**N9936A-01**

**S E R V I C E N O T E**

**N9936A - FieldFox Handheld Analyzer**

**FieldFox instruments with the serial numbers listed on the following page are being returned to Agilent factory so the RF board can be upgraded for reliability enhancement, due to possible oscillation by the voltage regulator on the RF board.**

Figure 1 shows a good RF signal, and Figure 2 shows FieldFox with sidebands issue.

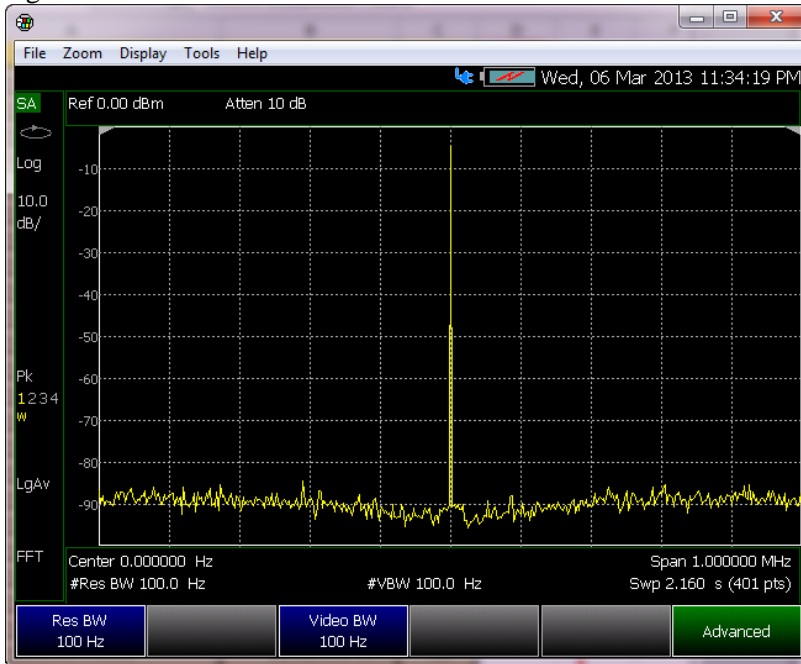
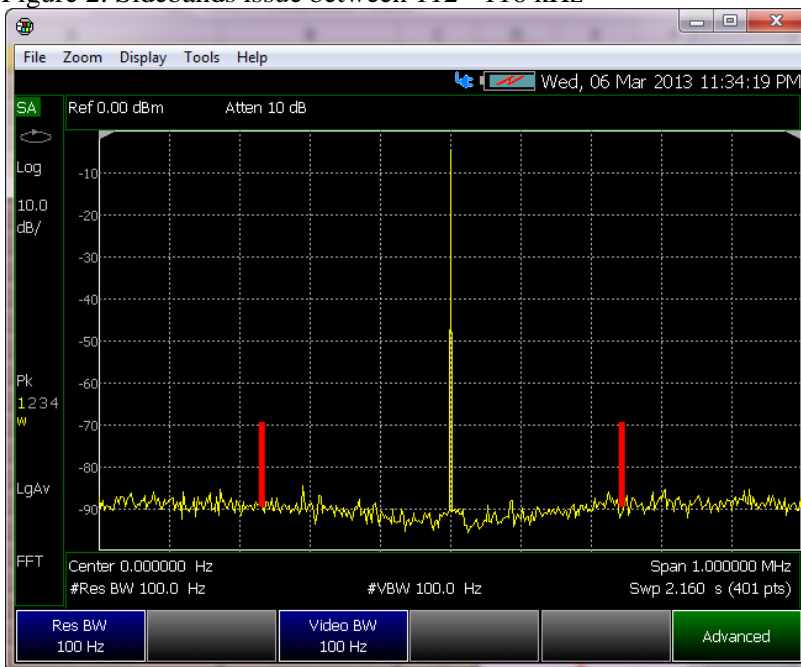
RF board earlier than Rev 7 may have sidebands issue due to oscillation by the voltage regulator. After it is fixed by replacing a new inductor, the RF board revision header will be updated to reflect the change.

Figure 1: No sidebands issue

Figure 2: Sidebands issue between 112 - 116 kHz

Affected FieldFox are required to send back to Agilent factory for RF board reliability enhancement. The RF board revision header will be updated to reflect the change. Test and Adjustment shall be done before shipping back to customer.
